2019 Annual Inspection Report

for Compliance with the Coal
Combustion Residuals Rule
(40 CFR Part 257)

Comanche Station

January 18, 2020

Appendix A – Cell 1 Topographic Survey

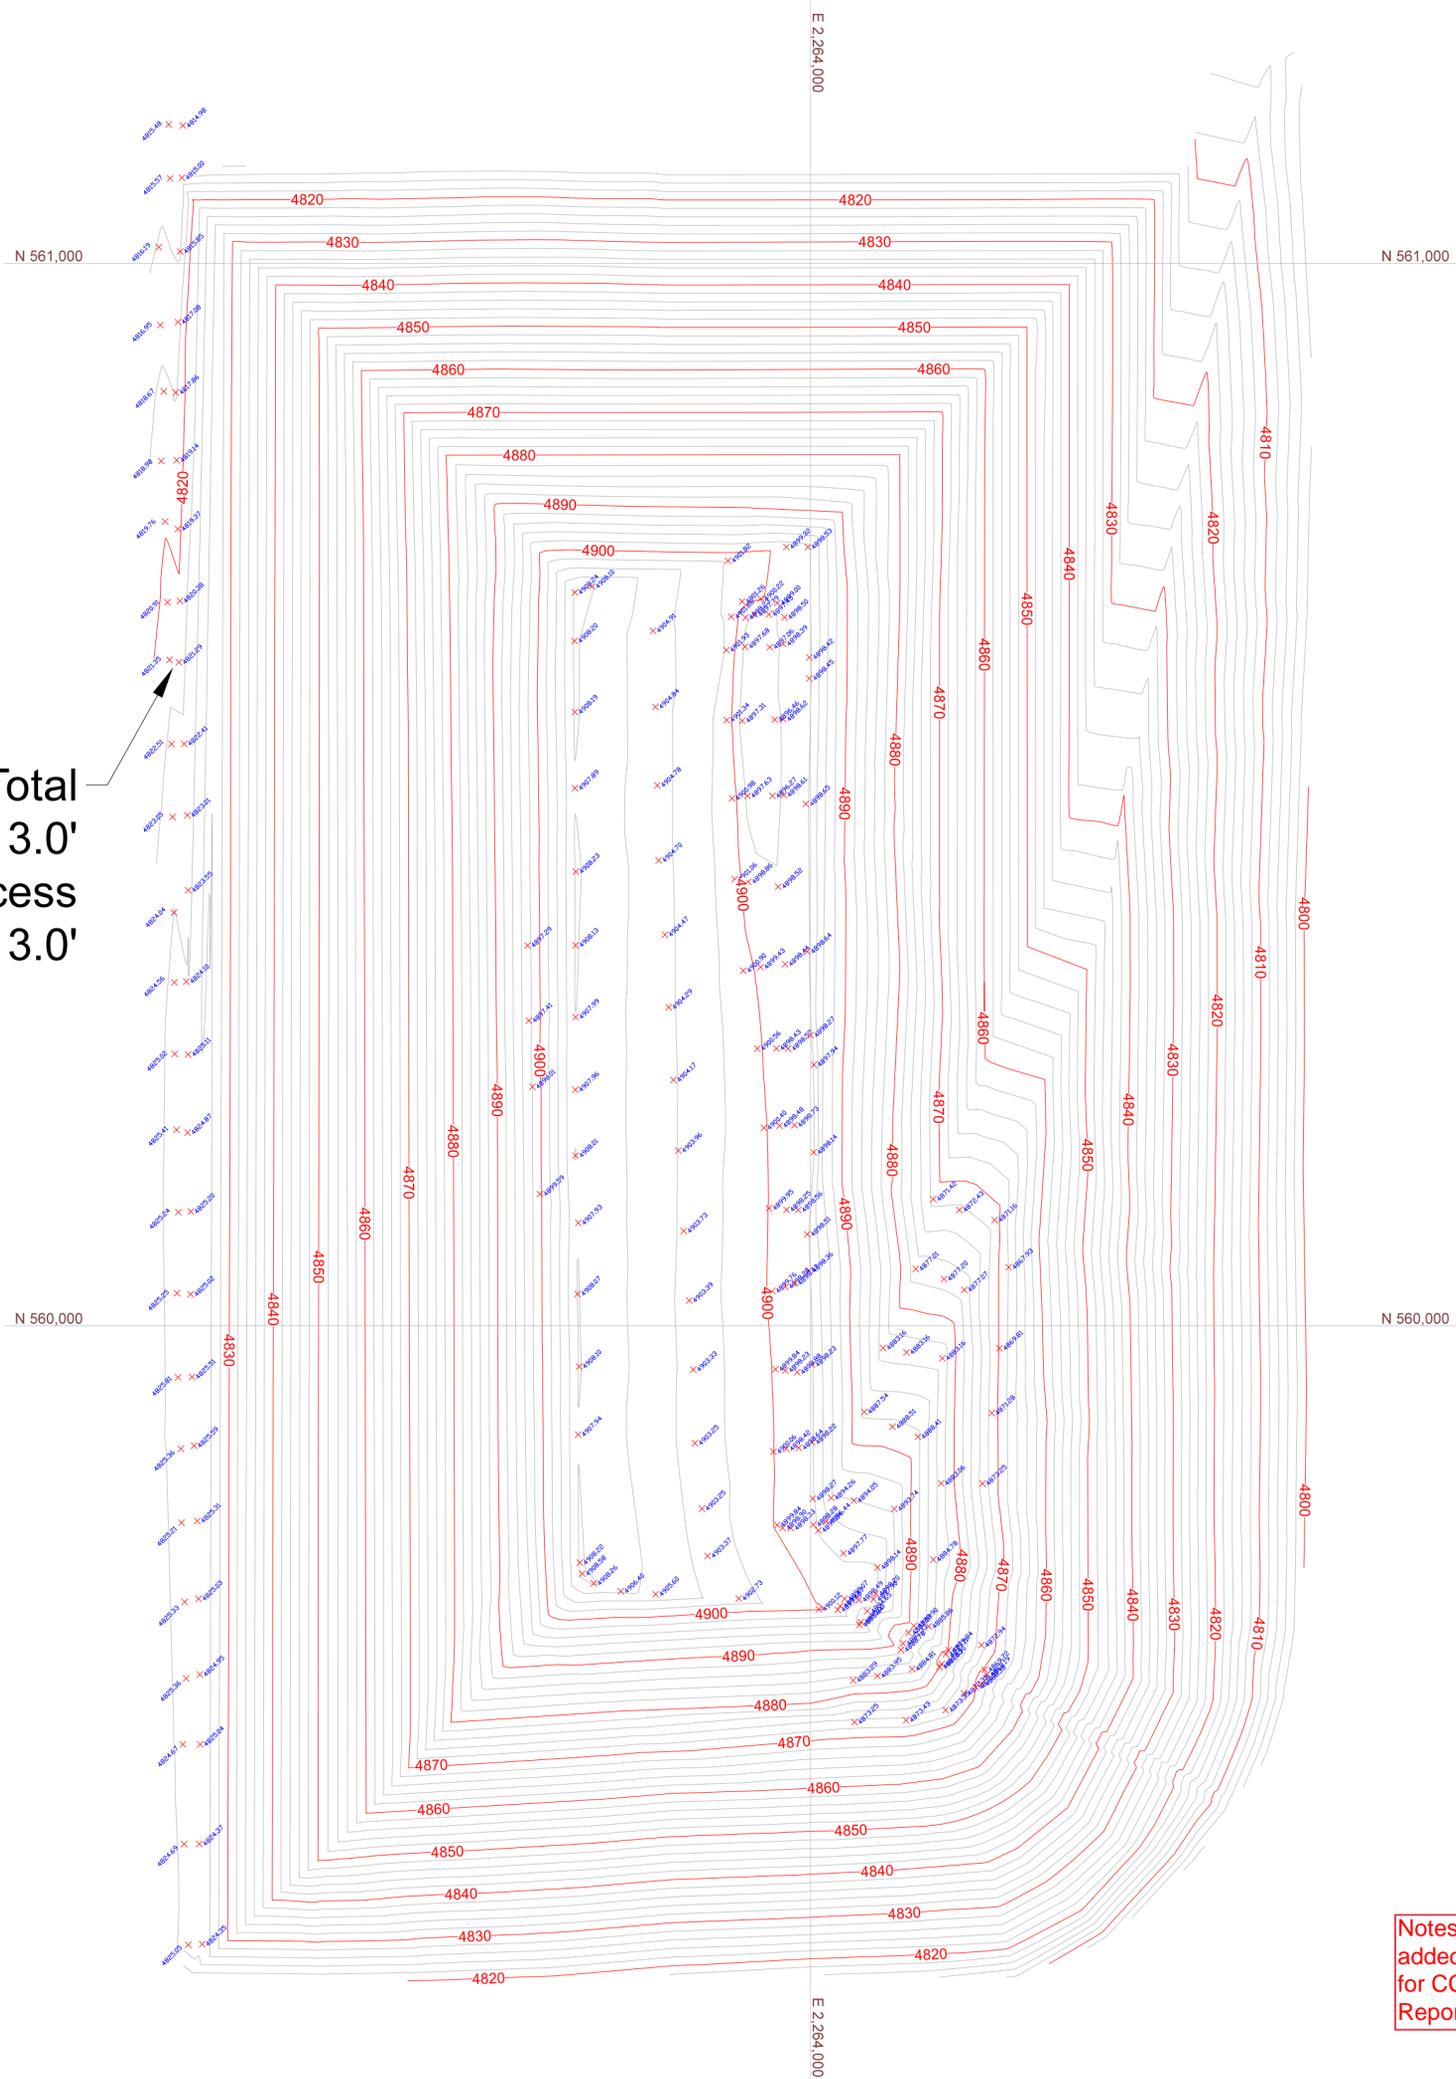
Volume Placed Dec. 2018 - Nov. 2019 - 90,735 CY
Current elevation of top of landfill - 4908'
Final elevation of landfill - 4910'

Volume shown
is for Cell 1 only.

Notes in red text boxes
added by HDR Engineering
for CCR Annual Inspection
Report, January 2020.

COMANCHE GENERATING STATION ASH LANDFILL CELL 2 EAST-AS BUILTS DRAINAGE LAYER

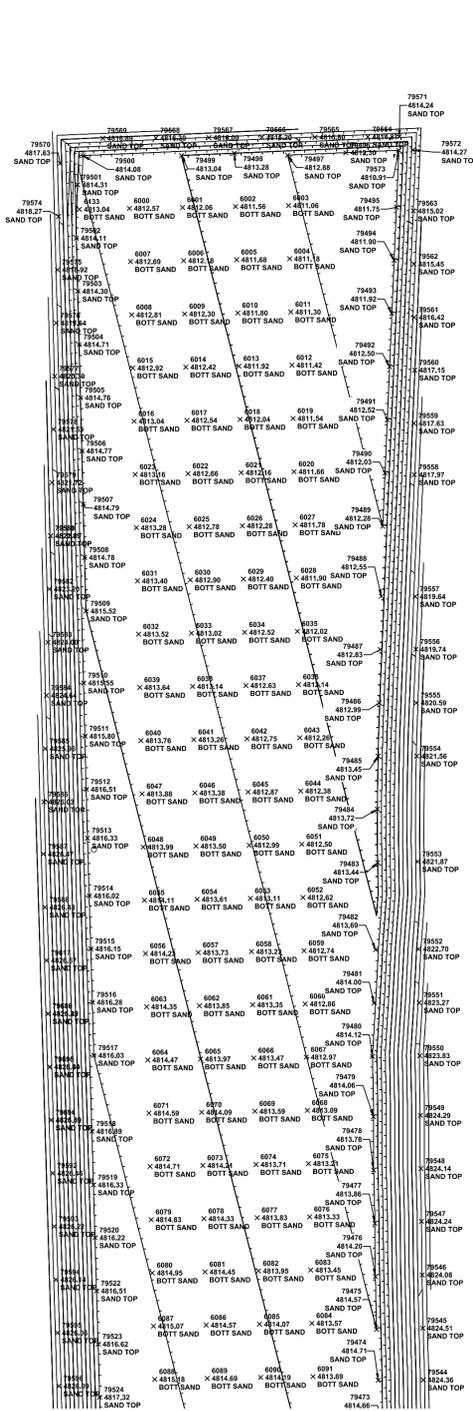
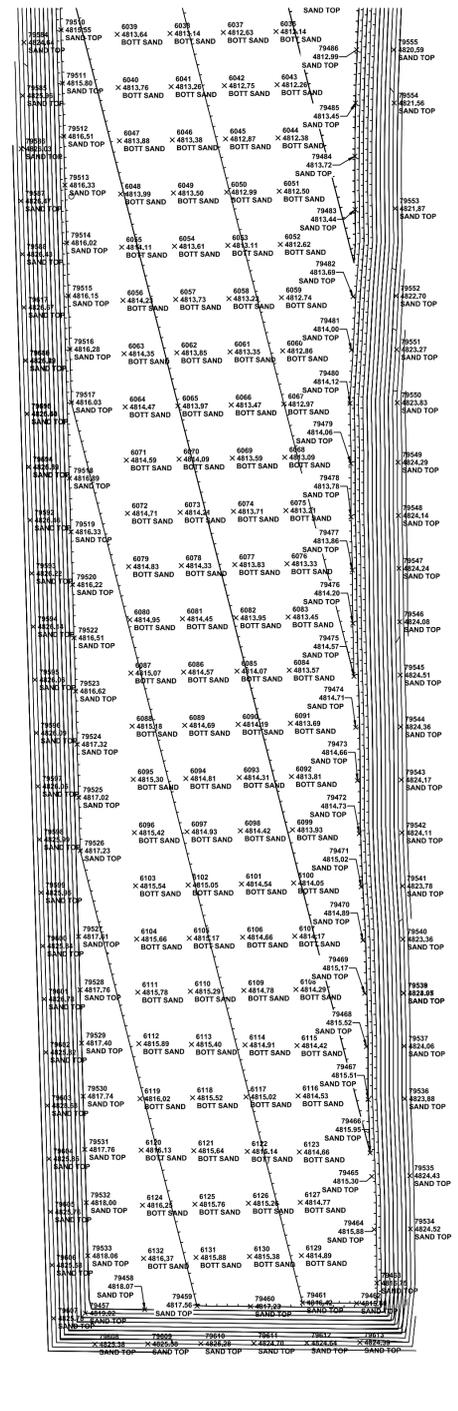
Approximately five feet of CCR placed above as-built grades - November 2019.

Notes in red text boxes added by HDR Engineering for CCR Annual Inspection Report, January 2020
